Access Compliance Report

Public Rights-of-Way

Intersection ID: 51062	Main Street: EDDLESTON_AV	Cross Street: TIPPERLINN_WY	Location: NW
ADA ID: 26626D7E0B9C	Ramp Type: PerpDiag	Initial Pass/Fail: Fail	Overall Compliance: No
Severity Score: 22.5			
Codes/Mitigation Info/Possible Solution		Field Measurements/Component Compliance

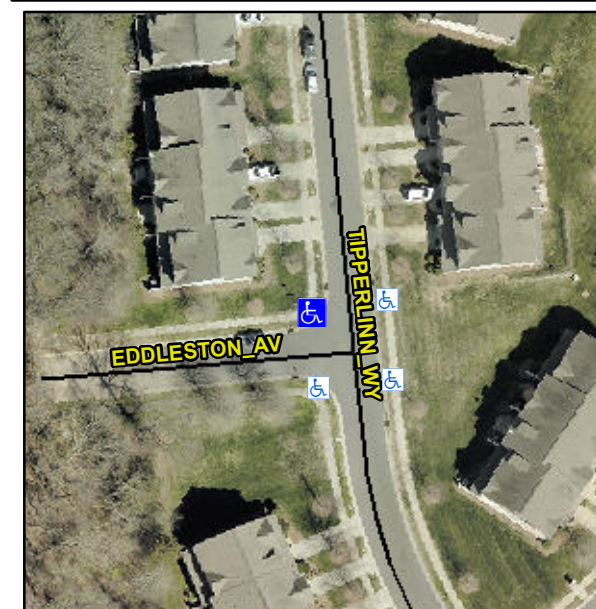
R304.5.1, R304.2.2, R304.5.3

Compliance	Description	Data	Compliance	Description	Data
N/A	Ramp Length (in)	46.5	No	Ramp Slope (%)	10.1
No	Ramp Width (in)	47.5	No	Ramp XSlope (%)	4.0
N/A	Flare Type LT	N/A	N/A	Flare Type RT	N/A
N/A	Flare Slope LT (%)	N/A	N/A	Flare Slope RT (%)	N/A
N/A	Flare Traversable LT?	N/A	N/A	Flare Traversable RT?	N/A
N/A	Landing Length (in)	N/A	N/A	DWS Provided?	N/A
N/A	Landing Width (in)	N/A	N/A	DWS Contrast?	N/A
N/A	Landing Slope (%)	N/A	N/A	DWS Length (in)	N/A
N/A	Landing X Slope (%)	N/A	N/A	DWS Full Width?	N/A
N/A	Landing Curb? (Y/N)	N/A	N/A	DWS Offset (in)	N/A
N/A	Shared Landing?	N/A			
N/A	Gutter Ponding?	N/A	N/A	Gutter Slope (%)	N/A
N/A	Gutter Lip Ht (in)	N/A	N/A	Gutter X Slope (%)	N/A
N/A	Painted X Walk1?	No	N/A	Painted X Walk2?	No
	X Walk 1 Direction	To S		X Walk 2 Direction	To E
N/A	X Walk 1 Width (in)	N/A	N/A	X Walk 2 Width (in)	N/A
	X Walk 1 Slope (%)	3.1		X Walk 2 Slope (%)	1.5
	X Walk 1 X Slope (%)	3.5		X Walk 2 X Slope (%)	3.9

N/A	Ramp inside XWalk1?	N/A	N/A	Ramp inside XWalk2?	N/A
	Road Slope (%)	5.5	N/A	Clear Space?	N/A
	Road X Slope (%)	1.1	N/A	Clear Space to XWalk (in)	N/A
N/A	Any Obstructions?	N/A	N/A	Storm Grate/Utility Hazard?	N/A
	Obstruction Type			Storm Grate/Utility Type	
		N/A			N/A
			Yes	Surface Condition? (G/P)	Good

Remove & Replace Curb Ramp With Two New Directional Ramps or Equivalent.
